REFERENCE:	Nova Bus Manuals
SECTION:	19: Fire suppression system
RS N°:	MQR 7621-N/A
EFFECTIVE IN PROD.:	L993 (201SE)

SUBJECT:	Fire suppression hose
JUSTIFICATION:	Fire suppression hose not certified.

Figure 1 - Remove the Access Panel

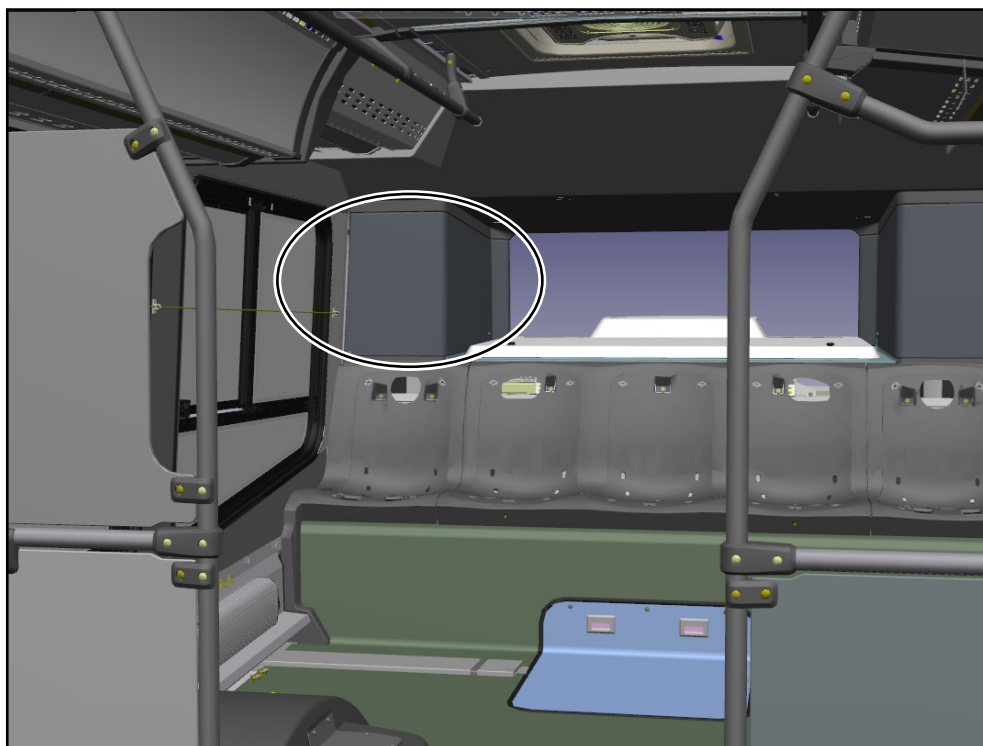
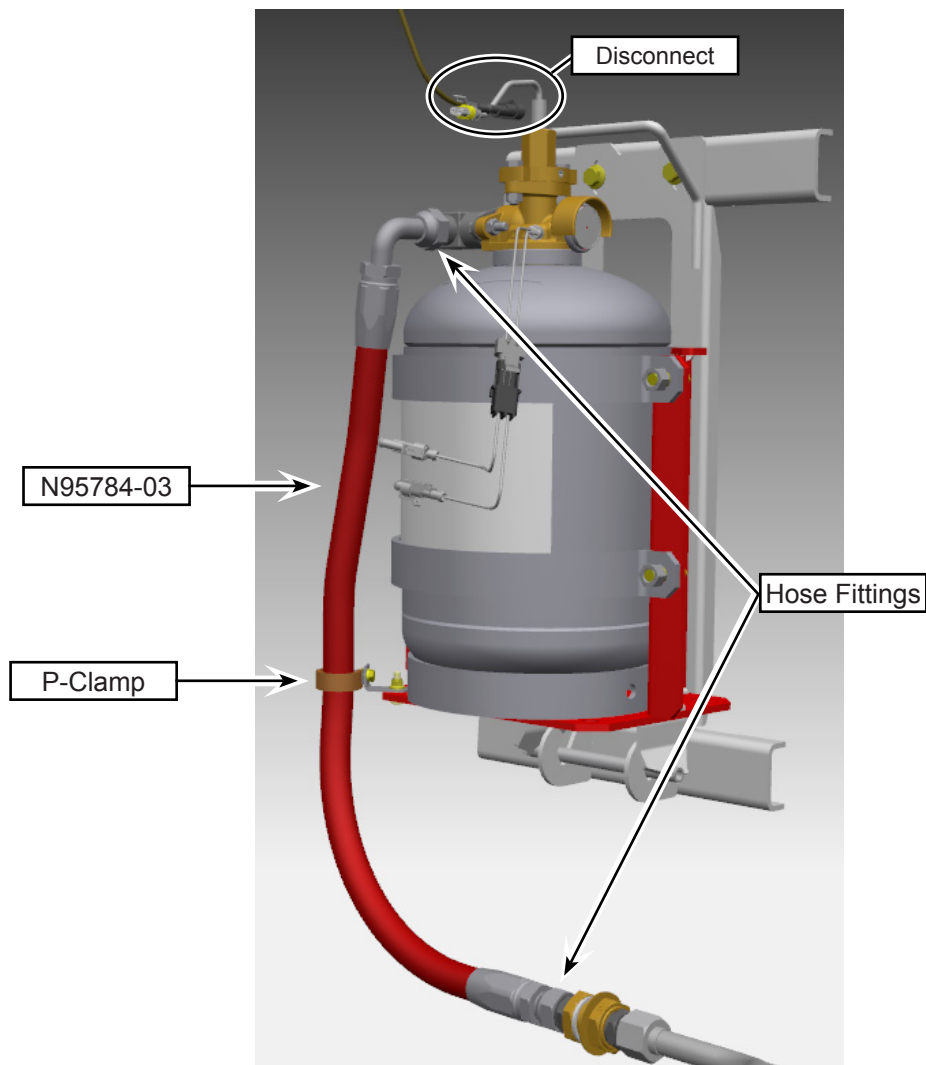
- 1.1. Remove the access panel on the curb side . See Figure 1.

- 1.3. Remove and retain the P-clamp.
- 1.4. Remove and replace the hose by the new N95784-03. Torque the hose fittings to 79-87 lb-ft (108-119 N•m). Apply a new anti-tamper seal.
- 1.5. Install the P-clamp.
- 1.6. Reconnect the electrical valve connection on the agent cylinder.
- 1.7. Install the access panel.
- 1.8. Return the vehicle in service. ❖
